Drawing Title: Comparison of east elevation

Job No: 2502 | Drawing No: SK05 | Rev: A

Job Title: 33 West Front Road, Pagham

Rev	Date	Revision Details	Dr	Ch
A	18.08.26	For discussion with Planning Officer	DH	AD

2. Proposal as drawn in granted scheme (1:125)

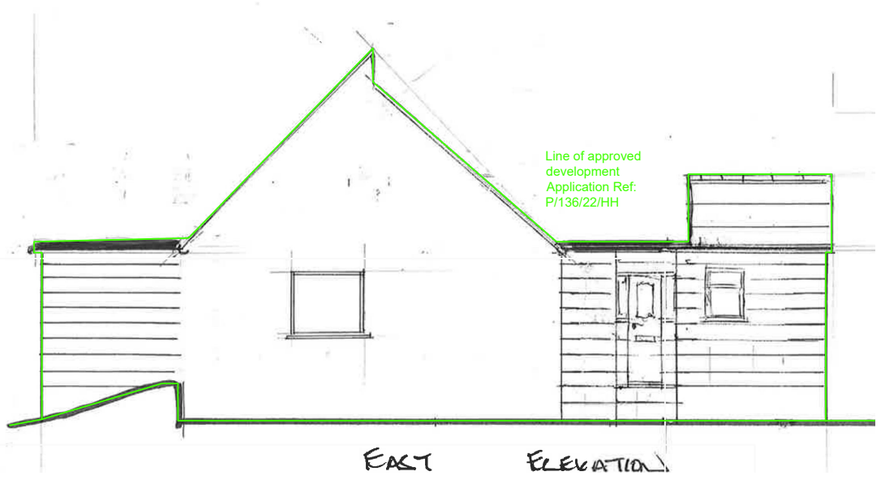
No levels on the proposal. Large step up to the front door (approx. 770mm).

4. New application to be submitted as Removal/Variation of Condition application (1:125)

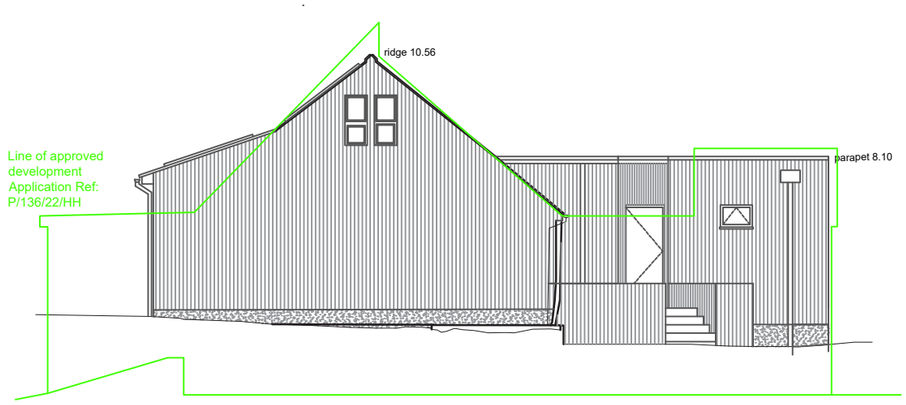
The proposed elevation shows the overclad and external insulation treatment. Retains the existing ridge height and shows a safe access point to the front door with rain gardens either side. The existing stain glass windows are to be reused and located higher in the gable end to improve daylight. The height of the parapet on the front extension is similar to the approved scheme.
